Palace Grand Theatre
Dawson City, Yukon
Project # R.068835.001

Addendum #M-001
2016-Nov-17
Page 2

Project title/Titre du projet
DAWSON CITY YUKON TERRITORY
PALACE GRAND THEATER
FOUNDATION / MECHANICAL / ELECTRICAL RENOVATION AND GENERAL UPGRADE

1 PARTIAL VENTILATION PLAN – ATTIC SPACE
SKM-001 SCALE: 1:100

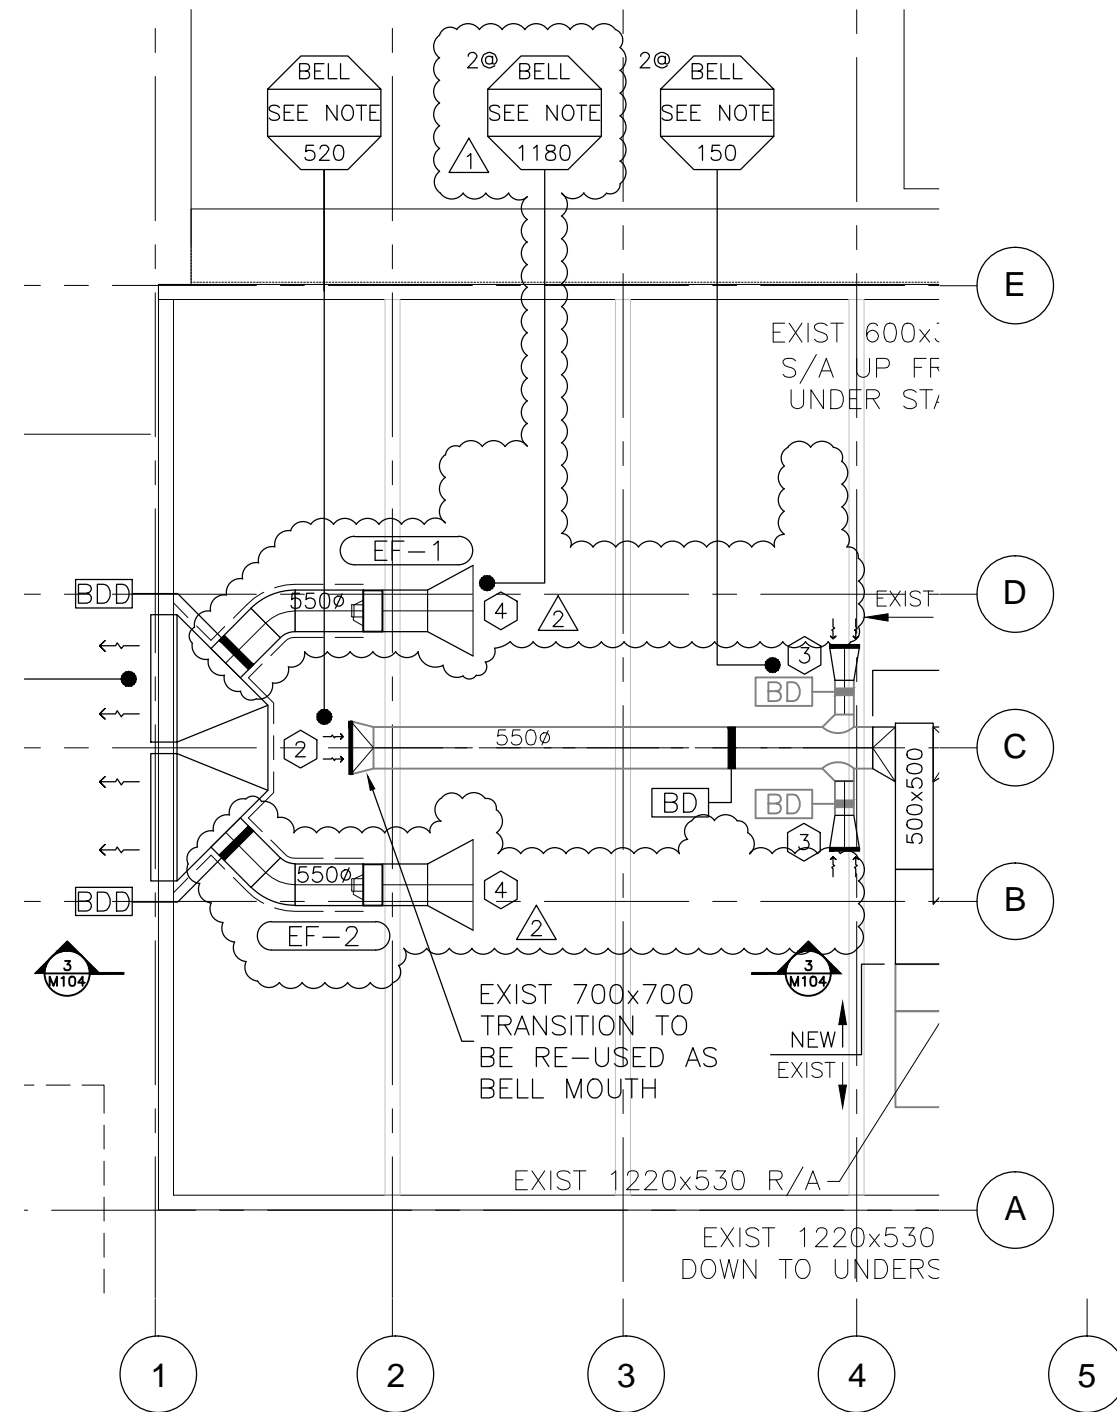
2. M104, plan 1. Revise smoke exhaust system between grid 1 & 5 as per attached sketch 1/SKM-001.

3 SMOKE EXHAUST FAN SECTION
SKM-001 SCALE: 1:100

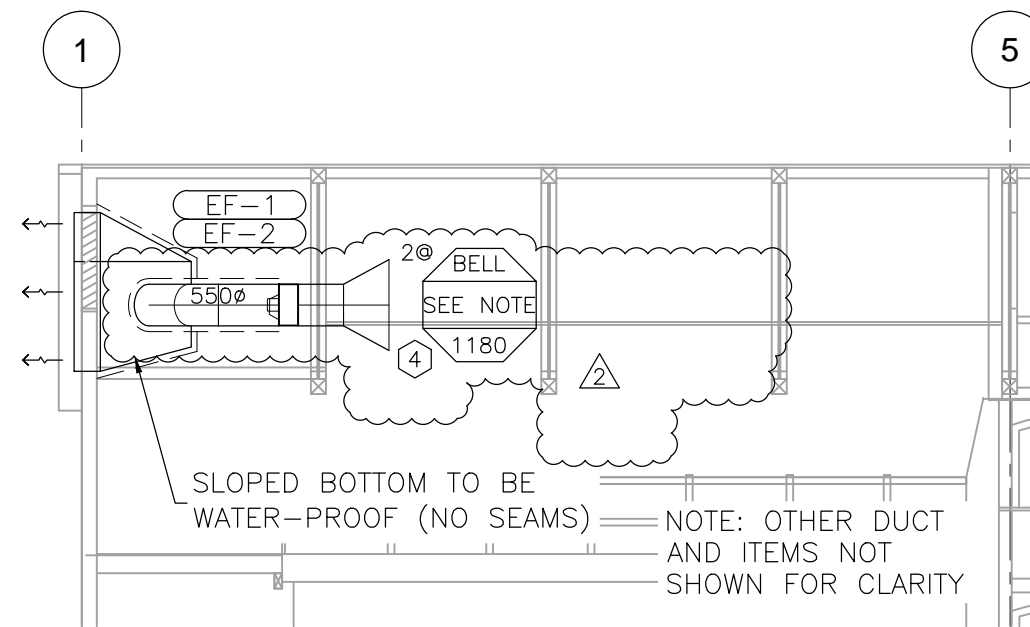
3. M104, plan 3. Revise smoke exhaust fan elevation as per attached sketch 3/SKM-001.

4. M104, Keynotes. Revise keynote #4 as per the attached keynotes on sketch SKM-001.
-

- KEYNOTES**
- ① INSTALL NEW FIRE DAMPER IN PROSCENIUM ARCH WALL.
 - ② PROVIDE 13x13mm BIRSCREEN OVER EXISTING OPENING
 - ③ RELOCATED 400Ø R/A BELL MOUTH C/W NEW 13x13mm BIRSCREEN OVER OPENING
 - ④ PROVIDE NEW 1200Øx600 BELLMOUTH C/W 13x13mm BIRSCREEN OVER OPENING

1 REVISED FUEL OIL SCHEMATIC
SKM-002 SCALE: NTS

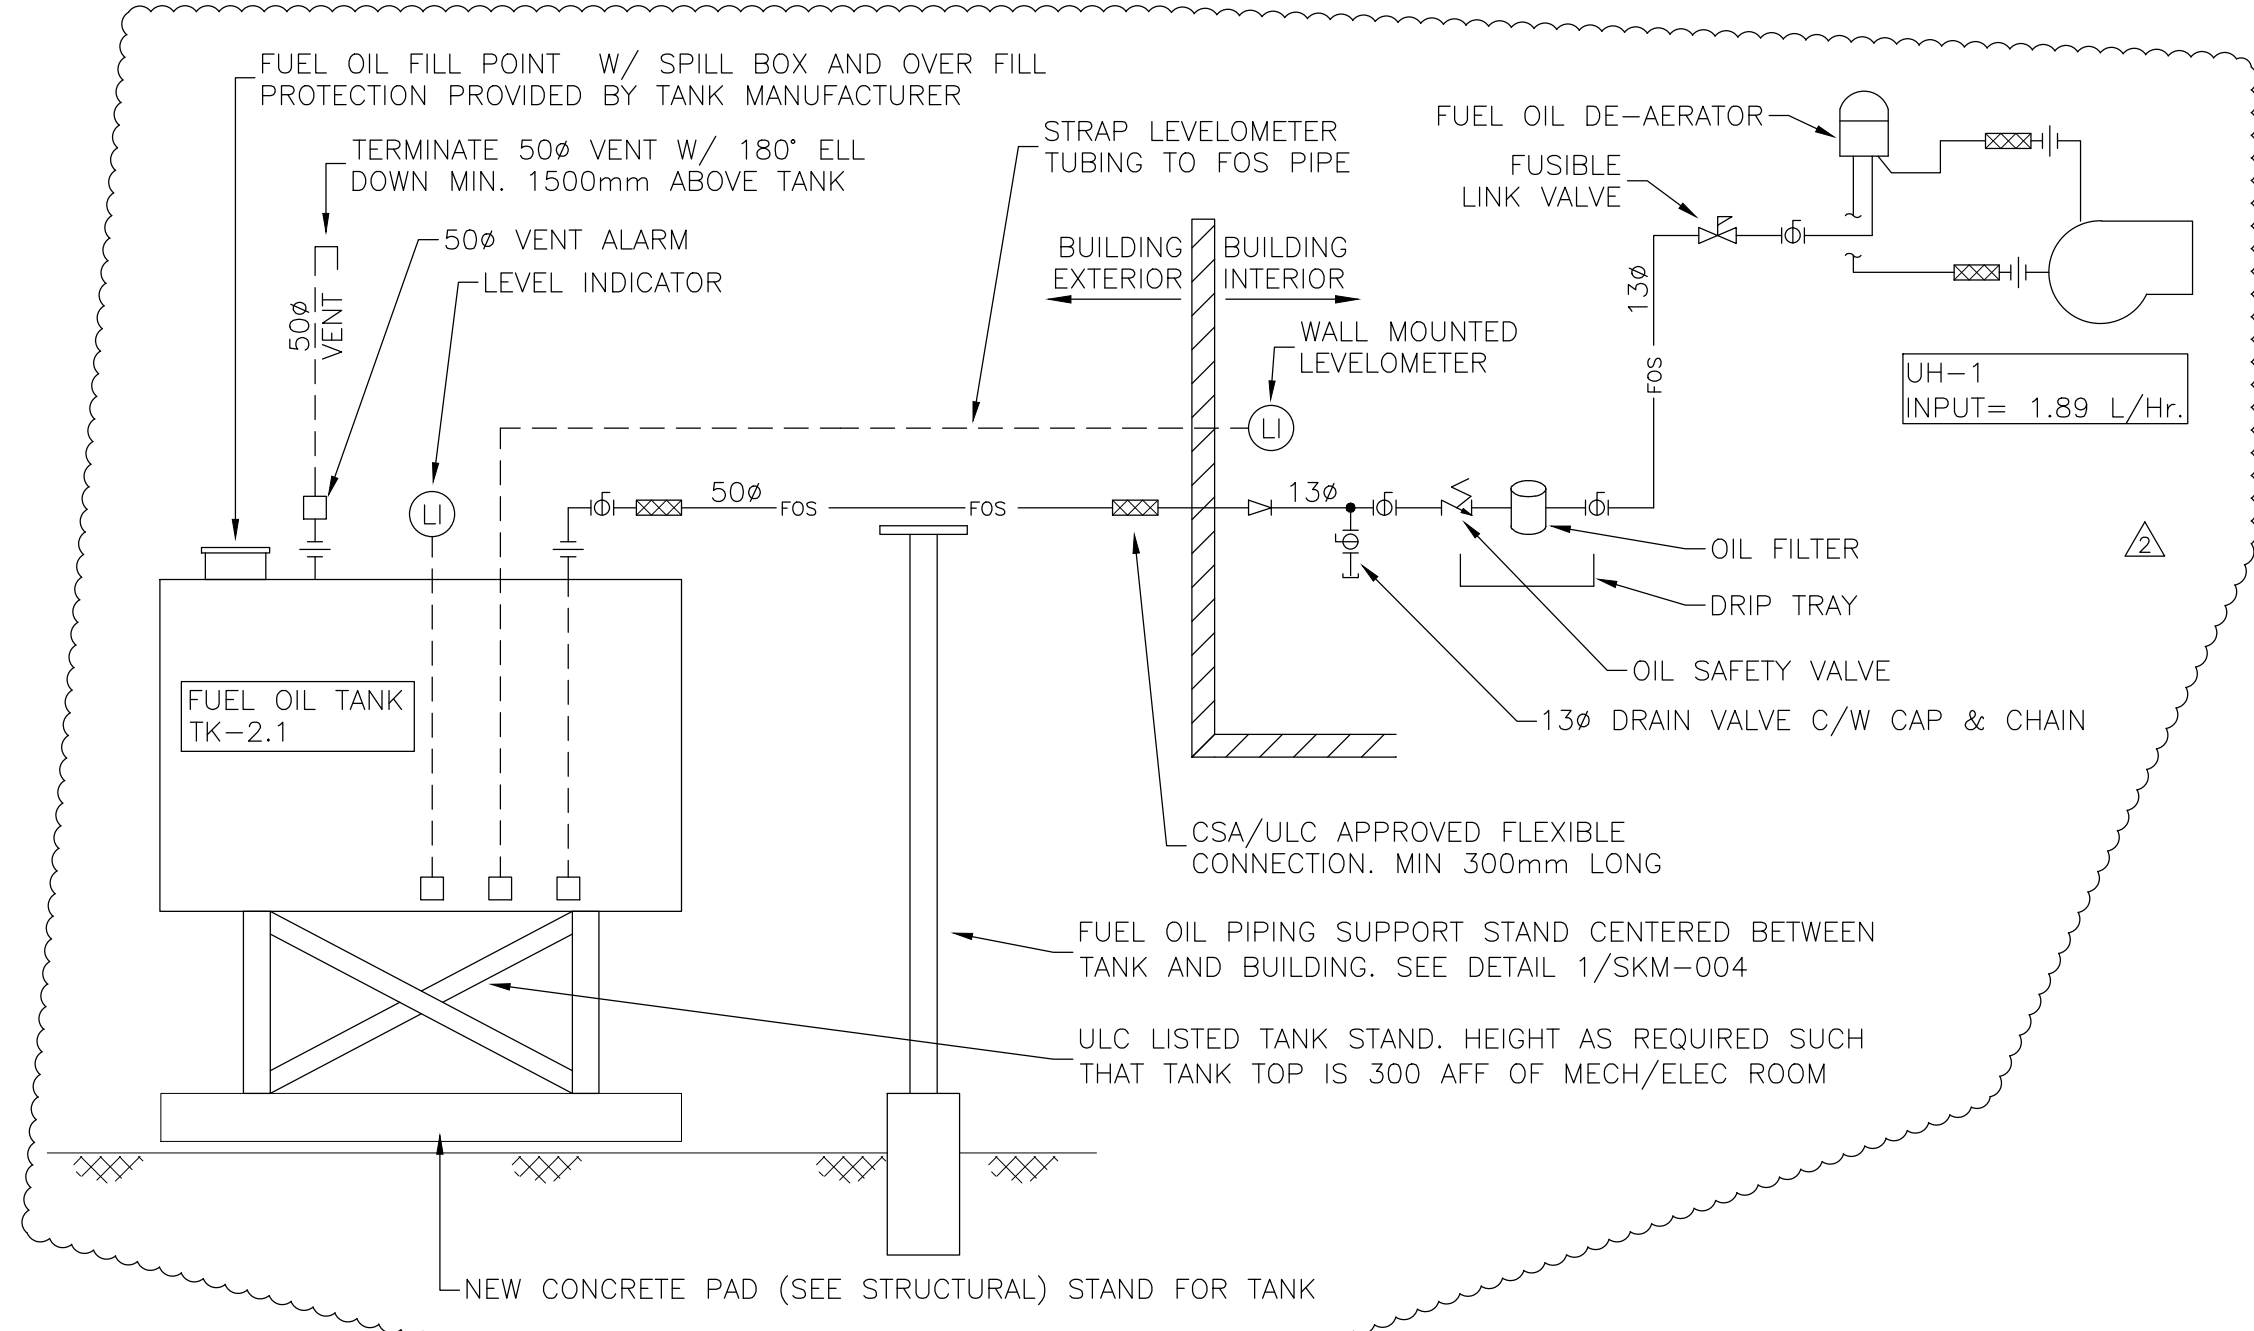
8. M601, detail 1.
 - a. Replace fuel oil schematic with attached schematic SKM-002.
 - b. Provide fuel oil tank stand per attached detail SKM-003.
 - c. Provide fuel oil pipe support per attached detail SKM-004.
